**Final  
ENVIRONMENTAL IMPACT REPORT  
for the  
MORISOLI-AMARAL (FORMERLY TAVERNETTI)  
RESIDENTIAL SUBDIVISION**

**SCH #: 97041029  
County File #: SH 92-01, SH 92-01**

**December 2004**

Figure A

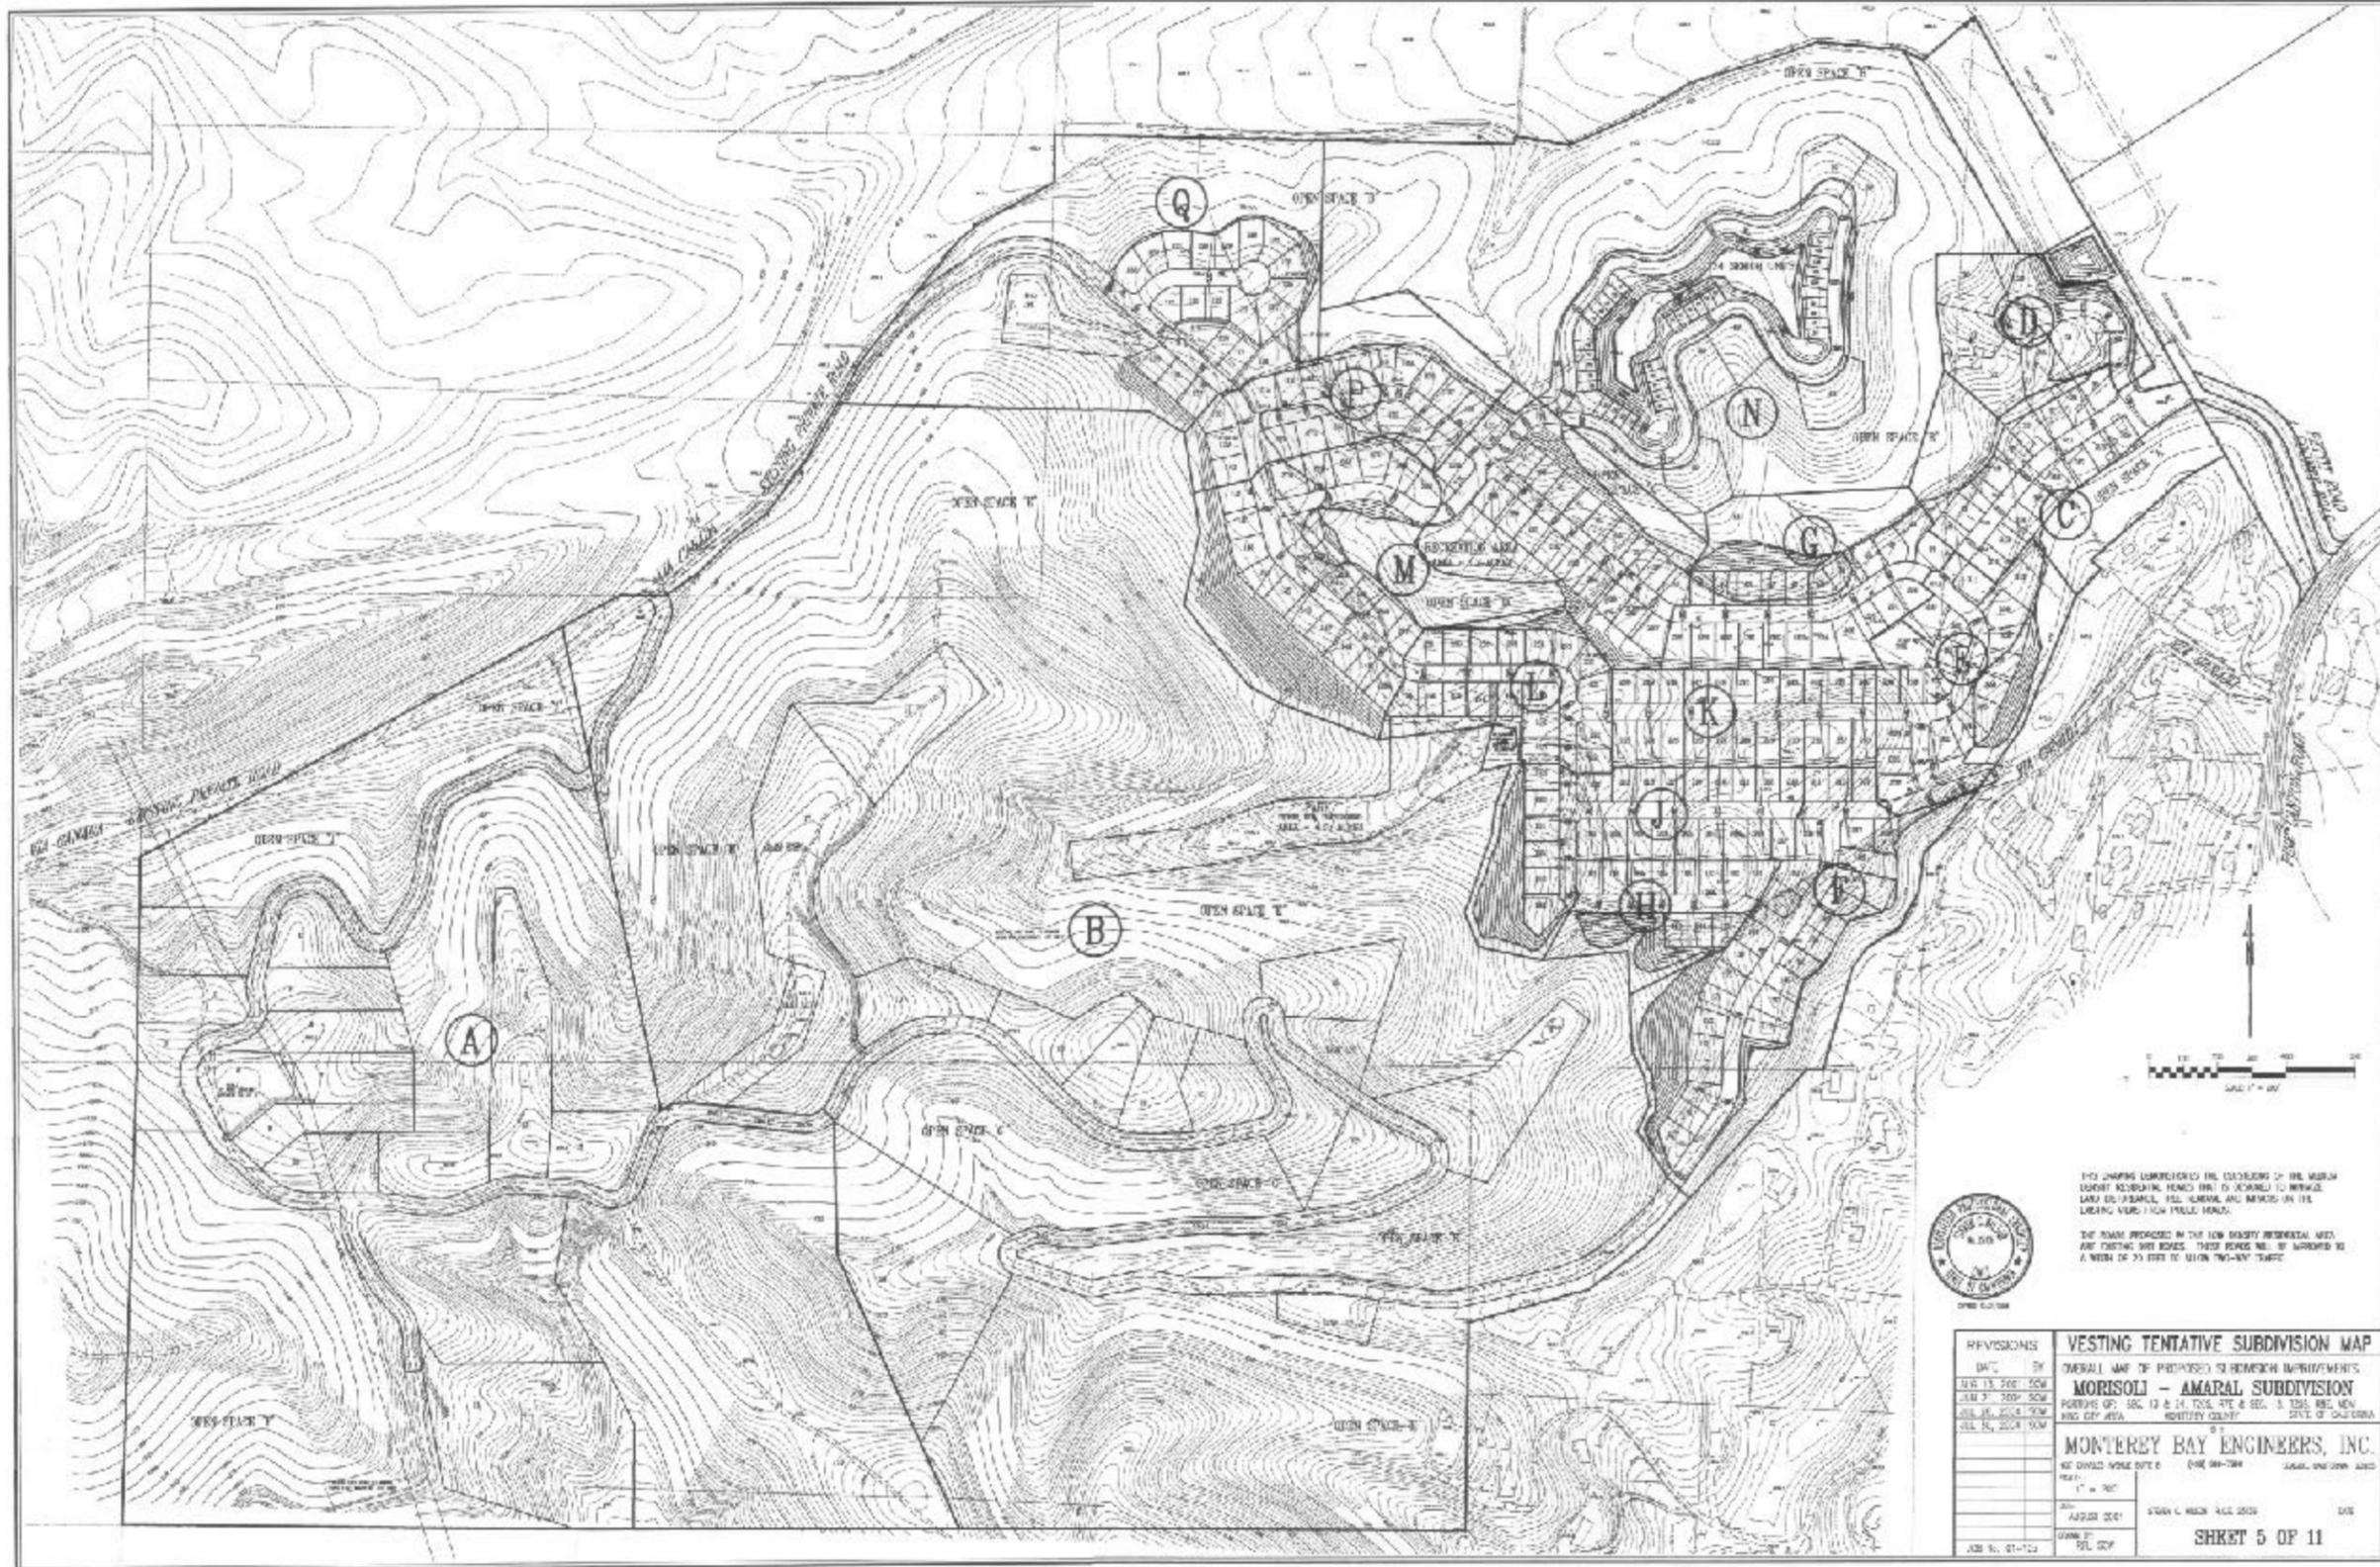
The proposed project will result in 319 residential lots on ~~411~~ 402 acres for an overall density of ~~.78~~ 0.79 units per acre. Revised Table 1 shows information about the proposed zoning, densities, and inclusionary residential component by phase as shown in **Figure 3 A**. The existing agricultural land use designations for the site are "Rural Grazing, 20 acres minimum," "Rural Grazing, 40 acres minimum," and "Permanent Grazing, 40 acres minimum." The project requires a general plan amendment and rezoning to be changed to residential, low and medium density. Lot sizes vary between 2,100 square feet and ~~21~~ 26-acres. Most of the lots are less than one-quarter acre. The higher density lots will connect to the Little Bear Water Company's wastewater treatment plant, to be upgraded by the project in order to accommodate flows from the residential subdivision. Lots larger than one acre will use septic systems and leach fields to dispose of wastewater. As shown on **Figure 3 A**, the highest density development is proposed on the rolling hills adjacent to the Salinas Valley and along the moderately sloping, east-west trending ridges. The plans show proposed locations of development envelopes on lots larger than one acre.

The project proposes ~~106.3~~ 210.8 acres of open space scenic easements. The total open space proposed including improved parklands (5.5 acres) and scenic easements, is 212 acres. The applicant has proposed scenic easements totalling 155.7 acres in Phases A & B (per VTM Sheet 4, dated July 2004). The proposed open space and scenic easement areas are shown on **Figure 3-A**. Generally, the scenic easements correspond with slopes greater than 30%, and ridgelines and knolls clearly within the Highway 101 viewshed.

FIGURE 3. PROPOSED STORM DRAIN SYSTEM

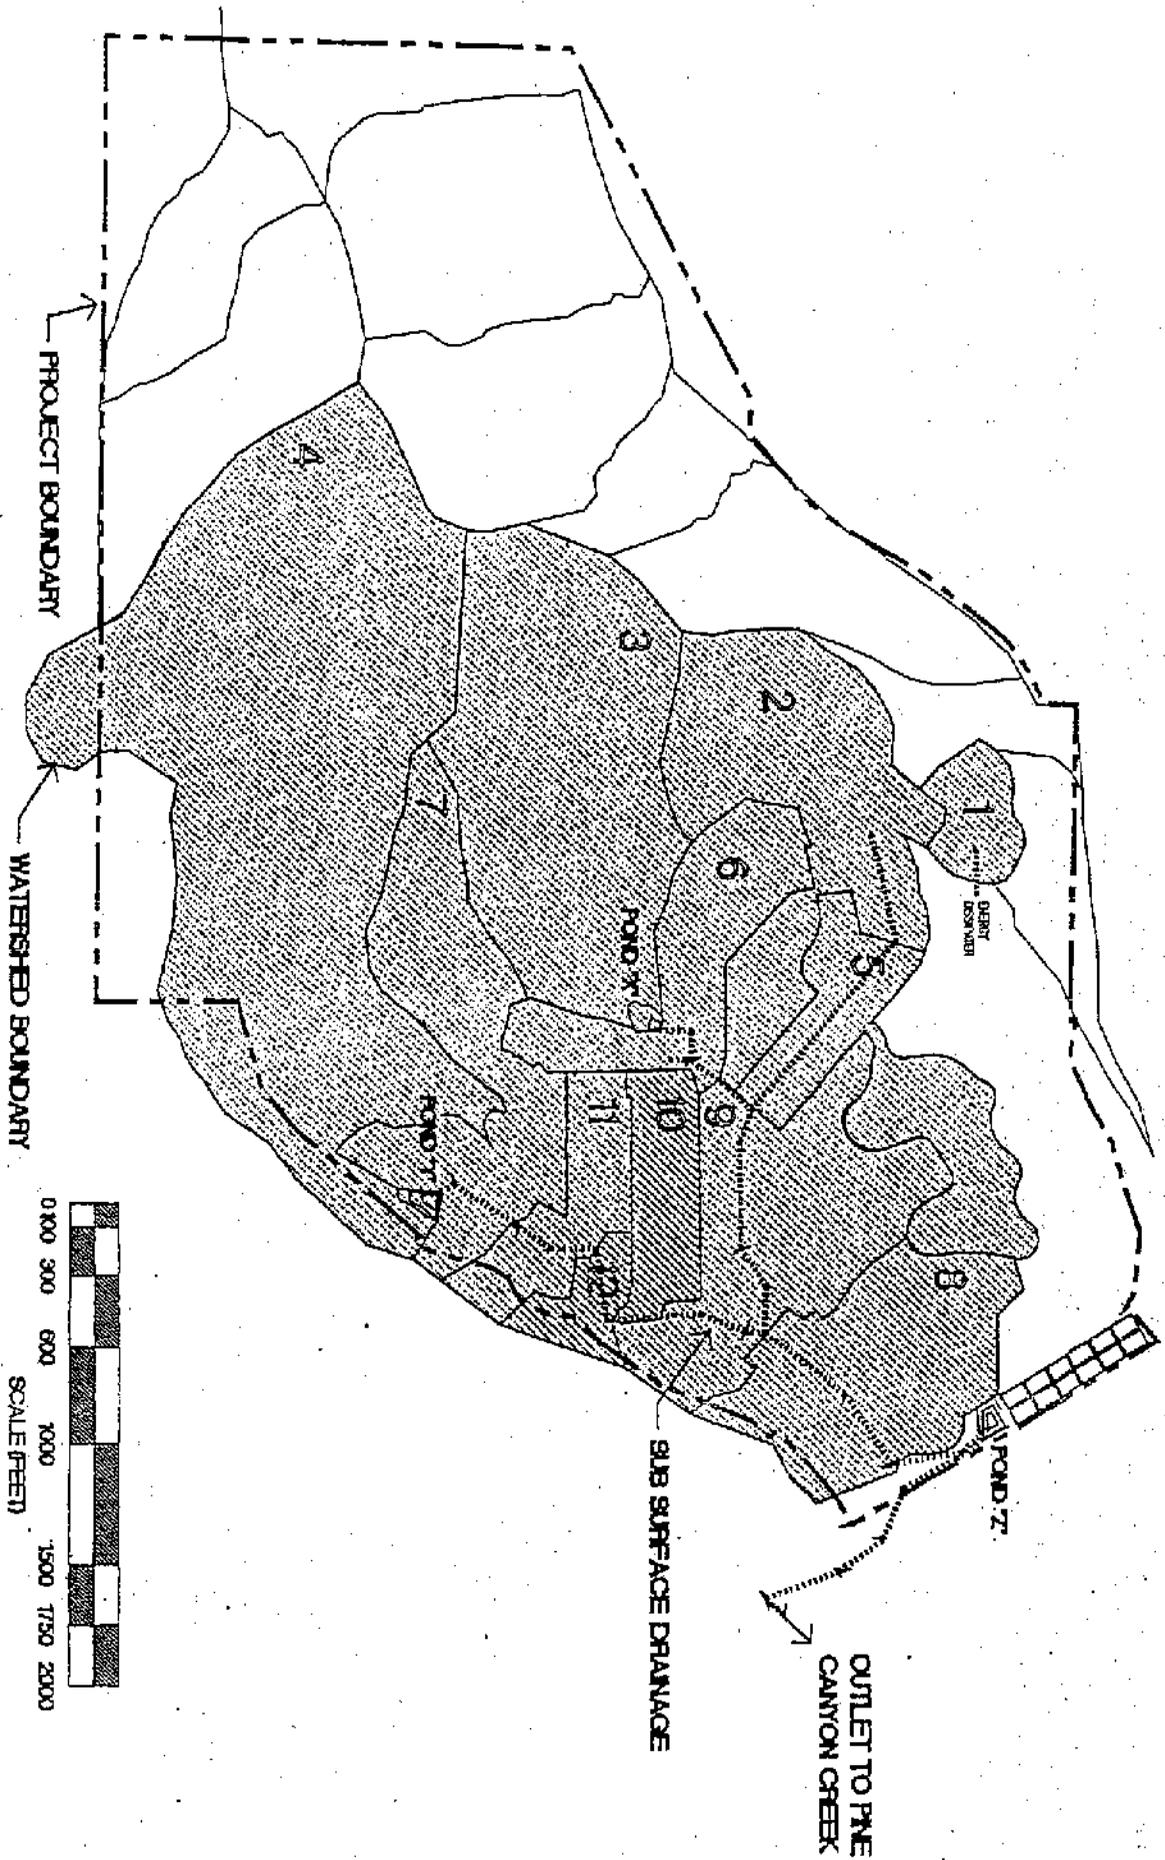
Proposed drainage improvements consist of a system of three (3) detention ponds, drainage channels, energy dissipaters and catch basins, with ultimate conveyance to Pine Canyon Creek and the Salinas River. Figure 15 3 of Appendix A, the revised hydrology report by Monterey Bay Engineers (September 4, 2002) depicts the proposed drainage plan. The revised total capacity of the detention ponds is 185,450 192,250 cubic feet, or 4.2 4.4 acre-feet. The original (June 2001) drainage plan also included three detention basins, with a slightly smaller total storage volume of 185,45 cubic feet, or 4.2 acre-feet. More importantly, however, the revised (September 2002) drainage plan proposes to locate one of the detention basins (Pond Z) at the bottom (northeastern) edge of the project site, providing that virtually all runoff from the project will be routed through detention facilities. The original (June 2001) drainage plan situated all three detention basins near the mid-elevation of the project site, with no runoff detention measures for the lower elevations in the easterly third of the project. Storm water runoff will be collected leaving the on-site detention basins will be and conveyed under the subdivision entrance road and Pine Canyon Road to an outlet structure at Pine Canyon Creek, approximately 2,000 feet from the confluence of Pine Canyon Creek and the Salinas River. The outfall structure will be designed to dissipate the energy of the flow and minimize erosion at Pine Canyon Creek. In addition, the hydrology report recommends installation of oil and grease traps. This measure is required to mitigate for operational surface water quality impacts.
